Product Change

perma PRO C and perma PRO C LINE with exchangeable support battery

1907-01-00

2019-07-26

Product update
Produktupdate

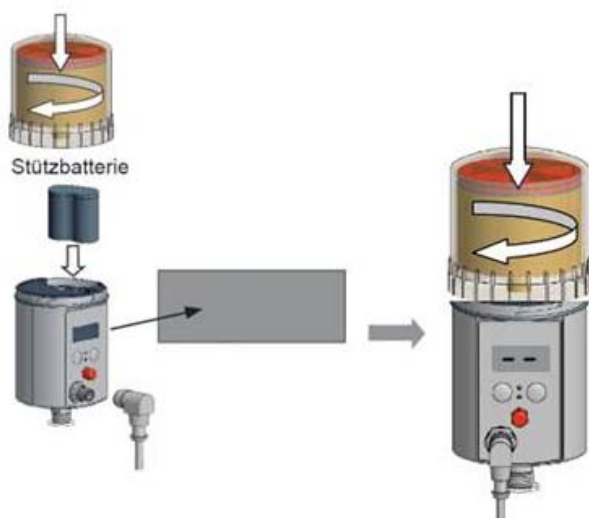
perma PRO C and PRO C LINE will soon be equipped with an exchangeable support battery. Battery PRO B (Art. No.106953) will be used as the support battery. The previously used integral support battery will no longer be used.

The display shows "Lo" when the support battery is empty. This does not impact system function: Configuration does not change and there is no error signal to the PLC.

The currently used LC will empty despite the displayed „Lo“.

The support battery should be exchanged during the next LC exchange → no change of the setting → system starts with an initial run.

When the distributor MP-6 is connected, system will start with an initial run as soon as power is applied.

After the initial run, the system continues to operate with the previous setting.
